CODE AMENDMENT FORM

ITEM NO:	(DCA USE ONLY)	PAGE <u>1</u> OF <u>1</u>
CODE: 2023 N	National Electrical Code	SECTION: Article 702
PROPONENT:	Director Chris Stallings, GEMA	DATE: <u>12/13/2025</u>
EMAIL: <u>Cl</u>	nris.Stallings@gema.ga.gov	
ADDRESS: 93	5 United Avenue	
TELEPHONE N	UMBER: 404-635-7200	FAX NUMBER: () -
CHECK ONE:	Revise section to read as follows:	Add new section to read as follows:
LINE THROUGI	Delete section and substitute the following: H MATERIAL TO BE DELETED:	Delete without substitution: UNDERLINE MATERIAL TO BE ADDED
Approve	Approve as amended (DCA STAFF O	NLY) Disapprove Withdrawn
DESCRIPTION: Requesting an ad that reads:	dition in the form of a Georgia Amendment to	Article 702 of the National Electrical Code
enabled with adea	ritical facilities that include hospitals, nursing quate installation of transfer switches suitable by powering such facility.	
	NT: nt during response to Hurricane Helene, critica sches. GEMA is able to provide emergency ger

Figure 1: GFCI Protection in Homes Versus Electrocutions 1975 to 2018 (Source: A NEMA Ground Fault Personnel Protection Section Article entitled "GFCI Receptacles: Consumer Protection Personified" June 2020, Revision 2).

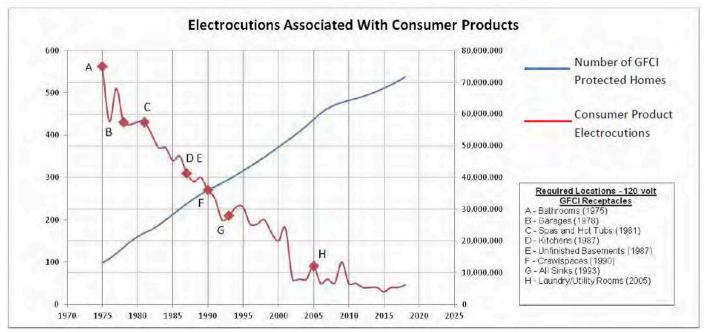
GFCIs have been an unmitigated success, contributing significantly to reducing deaths due to electrical shock. In just 25 years after GFCIs were introduced, accidental electrocutions in the United States were cut by more than half, even though electricity use more than doubled1. There is a clear relationship between the reduction in electrocutions and the increased use of GFCIs over the last 45 years as indicated in Figure 1 below. However, this success has relied on requiring the devices in locations where dangers exist which they can protect against.

GFCIs are shown to be effective where a corded product is plugged into a standard "convenience" receptacle in a wet or damp location. However, the expanded requirement is for areas of the kitchen where handheld electric devices will never come near the sink. The extent of a "kitchen" is very open to interpretation and may include any dining and living areas connected to it in today's popular open floor plans. Many additional receptacles are covered by this new requirement.

Over 80 percent of the incidents cited as reason for this change in the model code resulted from people attempting to repair, modify or install an appliance while plugged in and contact occurring with the energized elements within the particular appliance. The NEC should not mandate GFCI protection for all kitchen outlets due to the clearly unsafe practices of unqualified individuals.
